CITY OF WESTMINSTER			
PLANNING APPLICATIONS SUB COMMITTEE	Date 12 October 2021		Classification For General Release
Report of Director of Place Shaping and Town Planning	Ward(s) involved West End		
Subject of Report	45-46 Adams Row, London, W1K 2LB		
Proposal	Erection of a second floor and third floor mansard extension to form three new residential units (Class C3) at second and third floor levels. Alterations including installation of plant equipment and waste storage at rear ground floor and plant equipment at roof level (site includes 46 Adams Row).		
Agent	Boyer London		
On behalf of	Forty Five Holdings Limited		
Registered Number	21/00257/FULL	Date amended/completed	16 February 2021
Date Application Received	15 January 2021		
Historic Building Grade	Unlisted		
Conservation Area	Mayfair

Permission is sought for the erection of a sheer second floor and third floor mansard extension to form three new residential units at second and third floor levels, with associated external alterations to the existing facades. Additionally, the application proposes the installation of plant equipment and waste storage at rear ground floor and plant equipment at roof level.

Proposed: Ground Floor

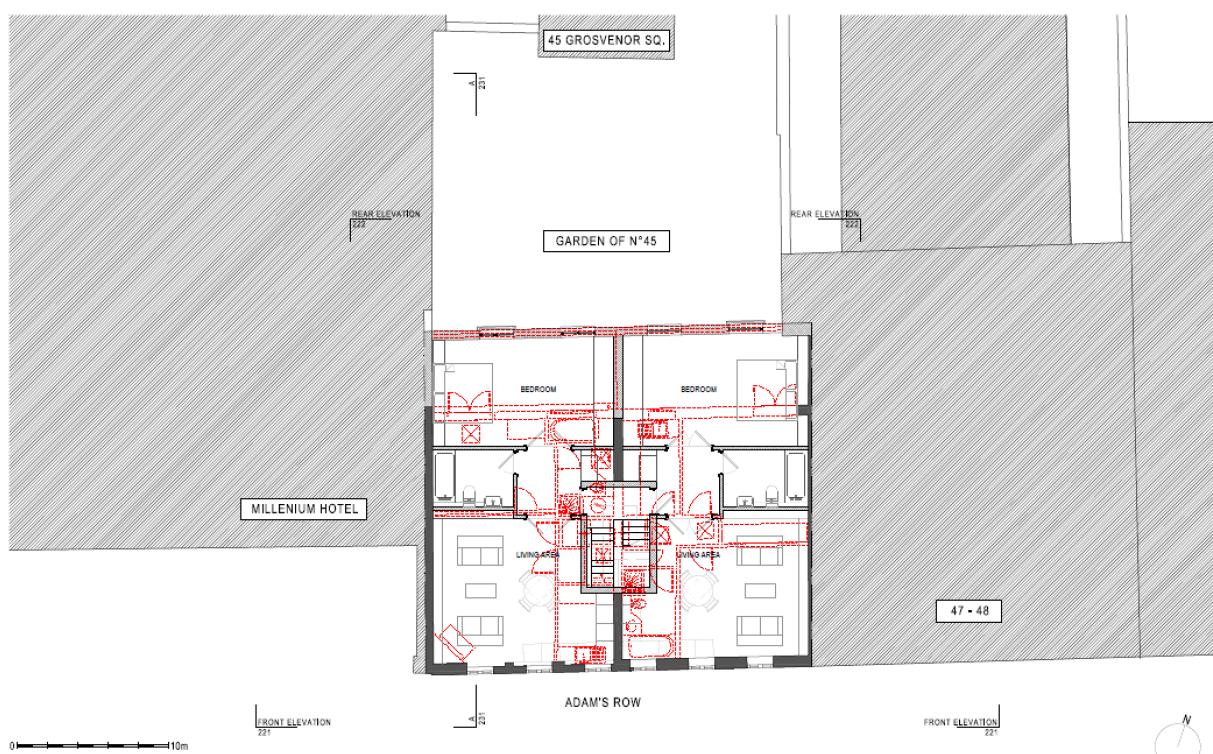
Waste Project Officer - Objection, the drawing submitted is not in line with the council waste storage requirements.

Objections are raised over the proposed location of the refuse/bin store, which is located at rear ground floor level and in close proximity to the rear of 45 - 47 Grosvenor Square, being detrimental to visual amenity. The waste project officer has objected to the application as the proposed details of refuse storage are not in line with the council's waste storage requirement. It is recommended that revised refuse and recycling details are secured by condition. It is acknowledged at this stage, given the details provided are not in line with the council's waste storage requirement, the proposed location is yet to be confirmed, and a revised location should be considered that ensures the refuse/bin stores are located internally at ground floor level whereby waste must be stored inside the property and only be put outside just before its collection.

- 8 Despite what is shown on "Drawing no: 0514 - PL - 211 Revision: B", you are advised before you occupy the second and third floor residential flats, you must apply to us for approval of details of how waste and recycling is going to be stored on the site. You must not occupy the residential use hereby approved until we have approved what you have sent us. You must then provide the waste and recycling store in line with the approved details prior to occupation, and clearly mark it and make it available at all times to everyone using the residences above. You must not use the waste and recycling store for any other purpose. Also, the waste must be stored inside the property and only be put outside just before its collection. ,

Proposed: Front Elevation

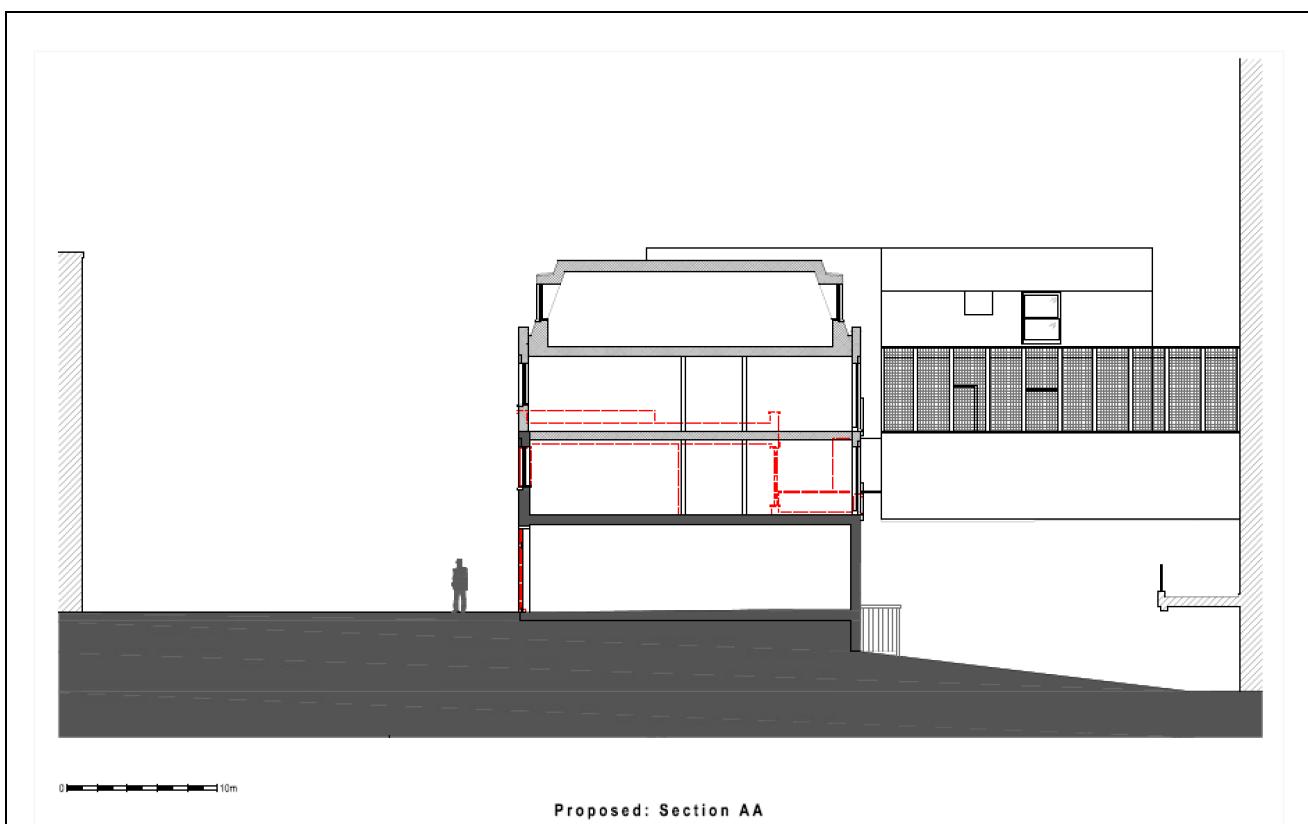
The proposed dormer windows are larger than specified in the Council's SPG, 'Roofs A guide to alterations and extensions on domestic buildings'. The guidance specifies that the dormer windows, including cheeks, should be no wider than the buildings on the storey below. The applicant has not chosen to decrease the size of the windows in this instance, despite officers requesting this. It is therefore proposed to have an amending condition that requires the windows to be reduced in size, in line with the advice within the SPG.

1. Reduction in the size of dormer windows in line with the advice in our SPG 'Roofs: A guide to alterations and extensions on domestic buildings';
2. The relocation of the rooftop plant enclosure to the north western portion of the roof;
3. The use of a standing seam metal covering for the flat portion of the mansard roof.
